**WLA4 - Retrofitting Heat Shield (Workshop Campaign)**

Revision: This bulletin replaces bulletin Group 1 19/20 WLA4, dated April 30, 2020.

Vehicle Type: **911 Carrera (991)**

Subject: **Heat shield on rear cross member**

*Installation position of heat shield*

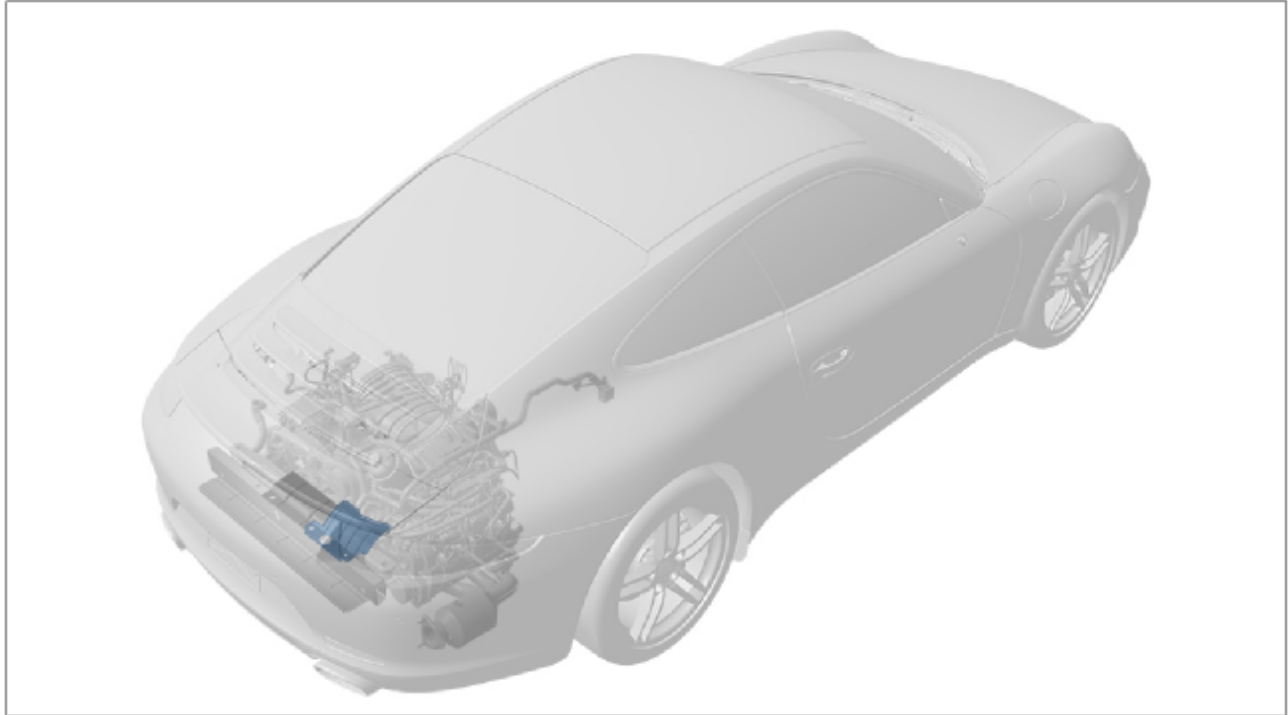
Information: **Foreign bodies, or material that is not part of the engine design or manufacture (e.g. cleaning cloths), in the engine compartment may touch hot exhaust system components, causing a potential fire hazard.**

Analysis of this damage has identified foreign objects or materials (e.g. cleaning cloths) found in the engine compartment as the cause of these incidents. Foreign objects or materials of this kind can touch hot exhaust system components while driving, causing them to ignite.

Remedial Action: Retrofit heat shield on rear cross member in the engine compartment. This shield may help to prevent any foreign objects or materials from touching exhaust-carrying or hot components in the engine compartment.
